Access Compliance Report

Public Rights-of-Way

(Curb Ramps)

Intersection ID: 29264	Main Street: SEEDLING_LN	Cross Street: WOODINGTON_LN	Location: S
ADA ID: 585120C8D2CE	Ramp Type: PerpDiag	Initial Pass/Fail: Fail	Overall Compliance: No
Severity Score: 33.75			
Codes/Mitigation Info/Possible Solution		Field Measurements/Component Compliance

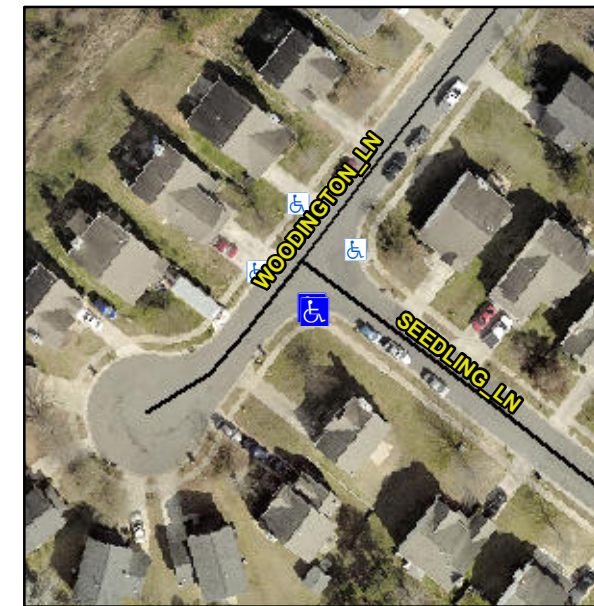
Not Found, R304.5.1, R304.5.3

Compliance	Description	Data	Compliance	Description	Data
N/A	Ramp Length (in)	48.0	Yes	Ramp Slope (%)	5.4
No	Ramp Width (in)	41.0	No	Ramp XSlope (%)	12.6
N/A	Flare Type LT	N/A	N/A	Flare Type RT	N/A
N/A	Flare Slope LT (%)	N/A	N/A	Flare Slope RT (%)	N/A
N/A	Flare Traversable LT?	N/A	N/A	Flare Traversable RT?	N/A
N/A	Landing Length (in)	N/A	N/A	DWS Provided?	N/A
N/A	Landing Width (in)	N/A	N/A	DWS Contrast?	N/A
N/A	Landing Slope (%)	N/A	N/A	DWS Length (in)	N/A
N/A	Landing X Slope (%)	N/A	N/A	DWS Full Width?	N/A
N/A	Landing Curb? (Y/N)	N/A	N/A	DWS Offset (in)	N/A
N/A	Shared Landing?	N/A			
N/A	Gutter Ponding?	N/A	N/A	Gutter Slope (%)	N/A
N/A	Gutter Lip Ht (in)	N/A	N/A	Gutter X Slope (%)	N/A
N/A	Painted X Walk1?	No	N/A	Painted X Walk2?	No
	X Walk 1 Direction	To NE		X Walk 2 Direction	To NW
N/A	X Walk 1 Width (in)	N/A	N/A	X Walk 2 Width (in)	N/A
	X Walk 1 Slope (%)	5.2		X Walk 2 Slope (%)	0.8
	X Walk 1 X Slope (%)	3.1		X Walk 2 X Slope (%)	9.9

Remove & Replace Curb Ramp With Two New Directional Ramps or Equivalent.
